PZ&B Staff Combination Memorandum: Landmarks Preservation Commission and Town Council

SUBJECT: ZON-24-0078 (COA-24-0030)_448 N LAKE WAY (COMBO)

MEETING: JANUARY 22, 2025, LPC
FEBRUARY 12, 2025, TC

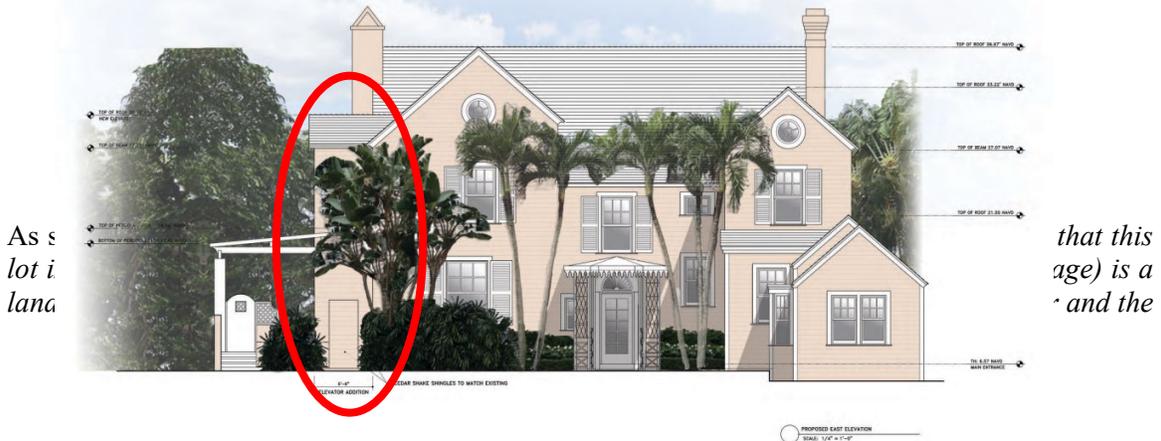
The proposed two-story elevator addition will require a variance from the first and second-floor minimum side yard setbacks on the south side of the property. The addition will have a 10.2' setback, whereas a minimum setback of 12.5' is required for the first floor and 15' for the second floor, as summarized in the table below:

Code Section	Required	Proposed	Variance
Variance #1: Sec. 134-893(b)(7)(a)	1 st Story: 12.5' Side Yard Setback Min.	1 st Story: 10.2' Side Yard Setback	2.3'
Variance #2: Sec. 134-893(b)(7)(b)	2 nd Story: 15' Side Yard Setback Min.	2 nd Story: 10.2' Side Yard Setback	4.8'

Staff concurs there is a hardship associated with the general narrowness of the lot (70 feet) as it relates to the historic placement of the ‘Vicarage’ on the property. Furthermore, the elevator addition is being proposed to accommodate a physical need of the current and long-time owner. For reference minimum lot widths in the R-B zoning district are 100’.
